**Subject:** RE: DA 2022 0033; 30A Addison Rd Manly WRITTEN SUBMISSION: LETTER  
OF OBJECTION SUBMISSION: JOHNS & BOLDING

RE: DA 2022 0033; 30A Addison Rd Manly  
WRITTEN SUBMISSION: LETTER OF OBJECTION  
SUBMISSION: JOHNS & BOLDING

The development application seeks approval for Demolition of a dwelling and detached garage, construction of a new two and part three storey dwelling and associated landscaping.

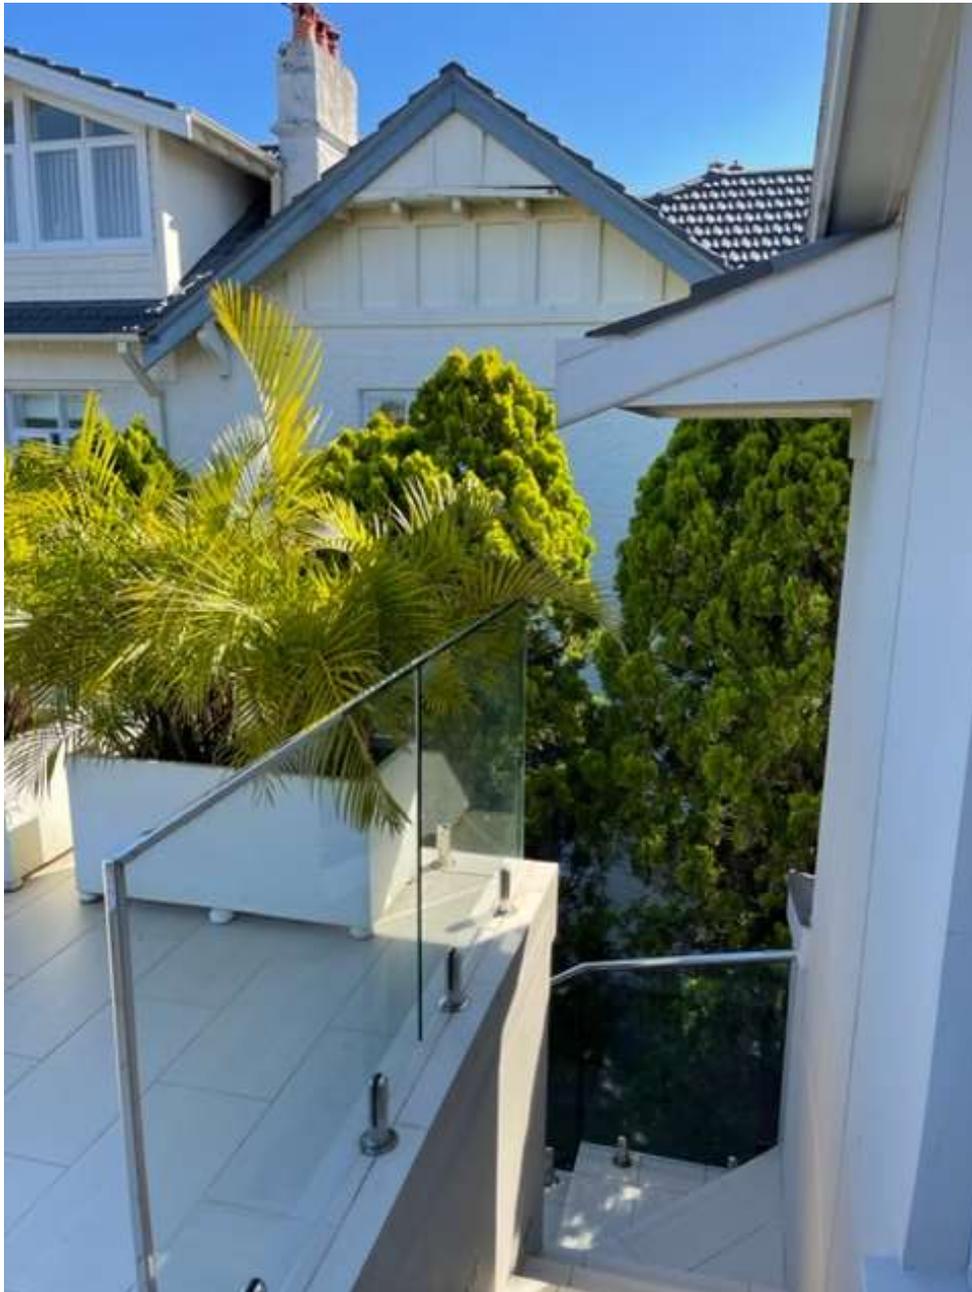
The following photos clearly show the amenity provided by the group of 17 *Thuja orientalis* adjacent the shared driveway. These trees are greater than 5m in height, and are considered to be significant trees.

These trees are in good health, and high amenity value as they provide significant privacy screening and general amenity value to all neighbours.

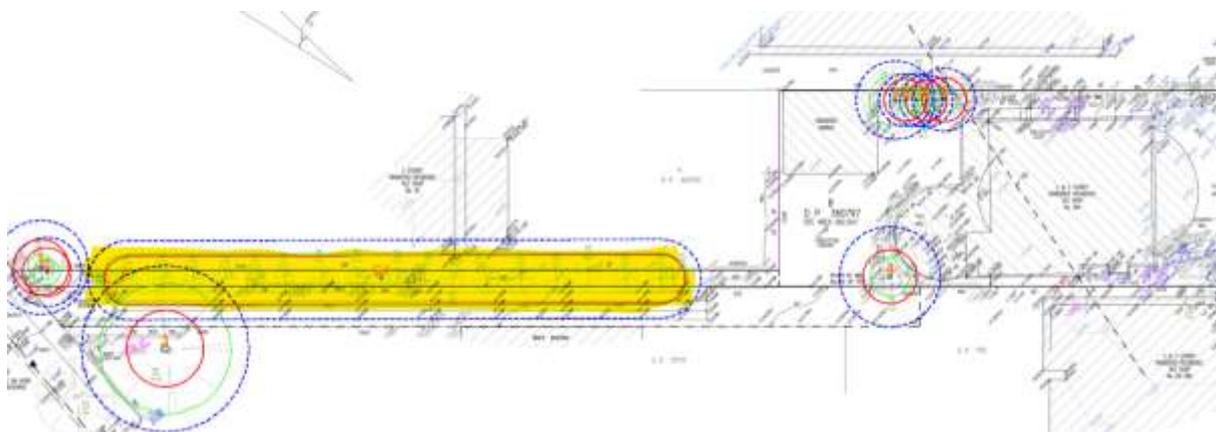
The common driveway which the 17 Thuja Orientals straddle services 6 different residences. Their removal would be gross overdevelopment. There already exists two concrete strips along the current driveway which are suitable as a pathway. There is no need to fell these 17 existing trees in order to build another 3rd path way. There is no doubt that their removal will have a detrimental impact on the

streetscape by virtue of their size and maturity as well as a loss of natural habitat for the native flora and fauna.

Mark-Up Roof Plan with Amended Plan Summary

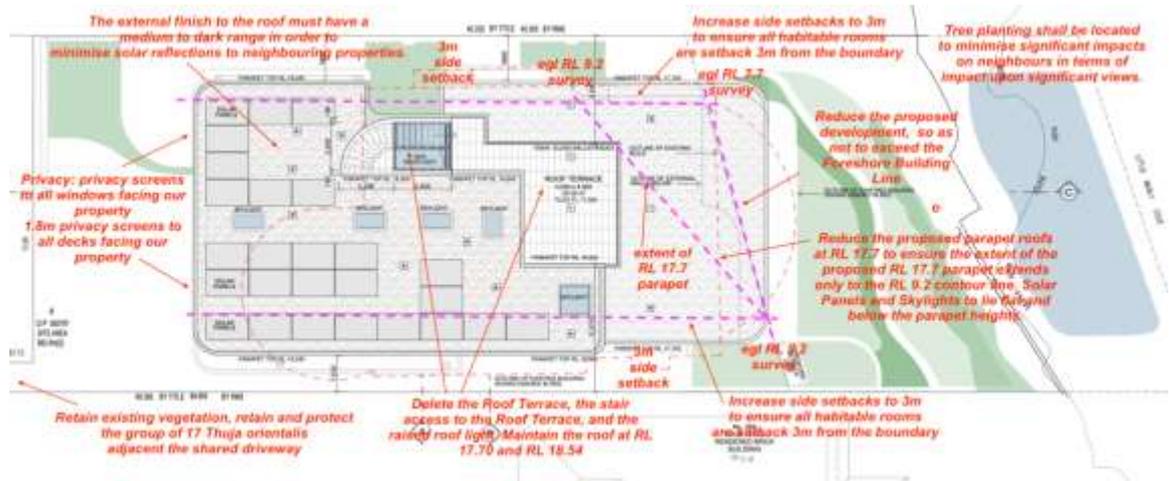
A compliant building design would reduce the amenity impacts identified. Reduce the proposed development as follow:

- Delete the Roof Terrace, the stair access to the Roof Terrace, and the raised roof light. Maintain the roof at RL 17.70 and RL 18.54
- Retain and protect the group of 17 Thuja orientalis adjacent the shared driveway
